Northshore Hamilton Major Road Package

Engineering Services Report

Approval no: DEV2024/1485

AMENDED IN RED

Figure 1 – Proposed Extent of Development within Northshore Hamilton PDA

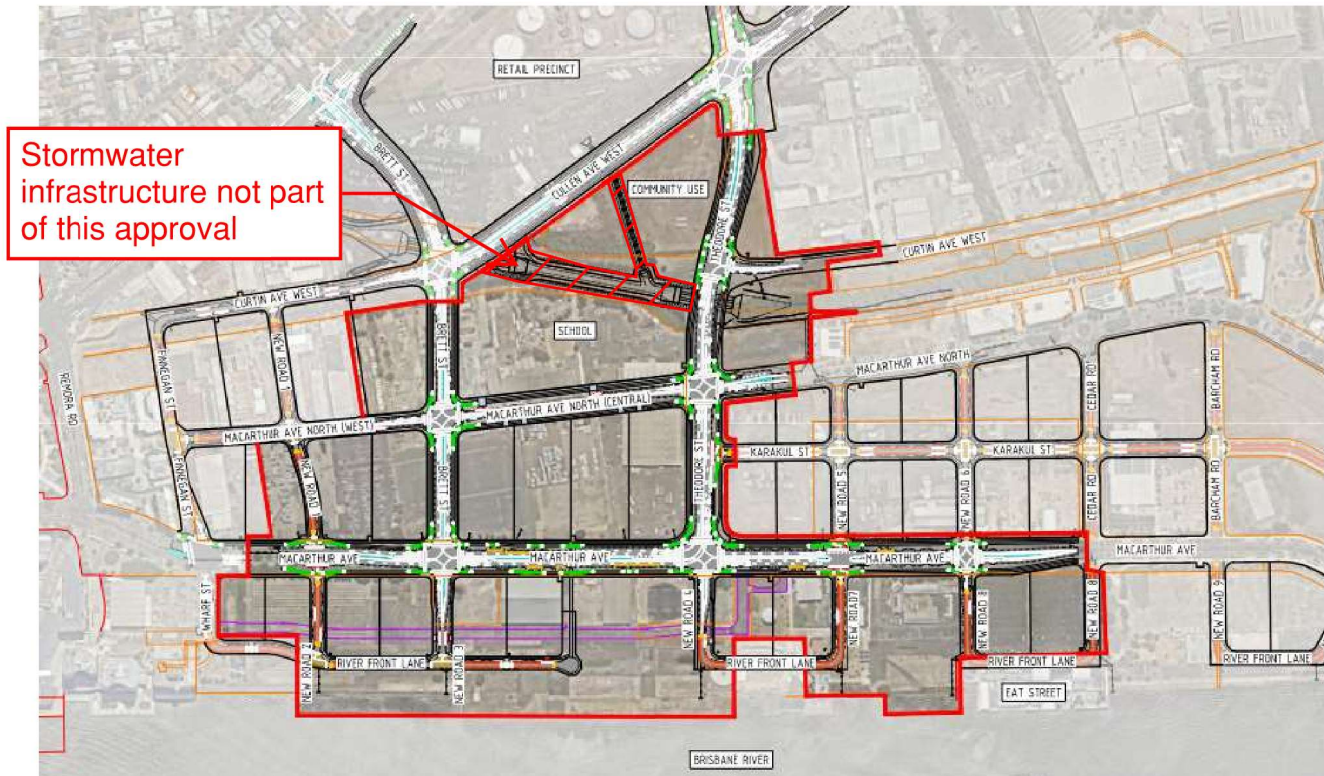
← Lot 1 on SP140140 is included within the application area
